Tennessee Valley Authority, 1101 Market Street, Chattanooga, TN 37402

CNL-18-015

Clinch River Nuclear Site
NRC Docket No. 52-047

Subject: Submittal of Revised Site Safety Analysis Report Figure 2.5.1-34 in Support of Early Site Permit Application for Clinch River Nuclear Site

Figure 2.5.1-34. Site Area Geologic Map

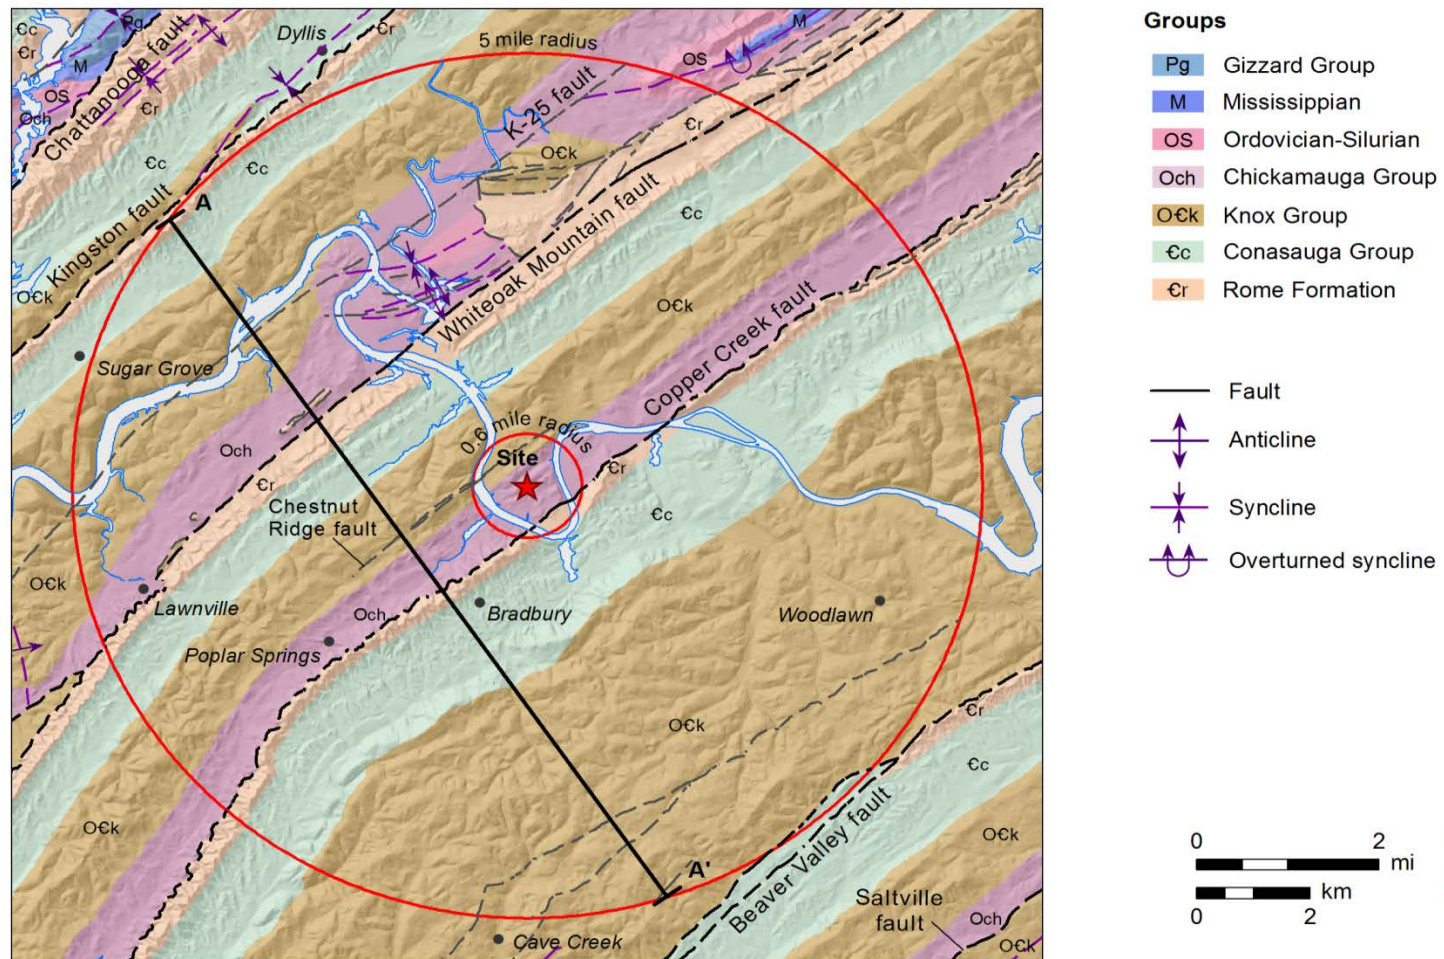
During a January 17, 2018 telephone call, the Nuclear Regulatory Commission (NRC) requested clarification on the revised Figure 2.5.1-34 submitted in Reference 2 regarding a shaded area located between the Knox Group and Chickamauga Group in the lower left quadrant of the figure. This shaded area was not indicated on the original Figure 2.5.1-34 submitted in Reference 1. Following review and comparison of the original and revised figures, it was determined the shaded area in the revised figure was unintentionally applied.

The purpose of this letter is to provide a corrected Figure 2.5.1-34 removing the shaded area in question. The corrected figure is provided in the enclosure to this letter. The corrected figure will be incorporated in a future revision of the ESP application.

SSAR Figure 2.5.1-34 is being revised and will be replaced with the following figure.
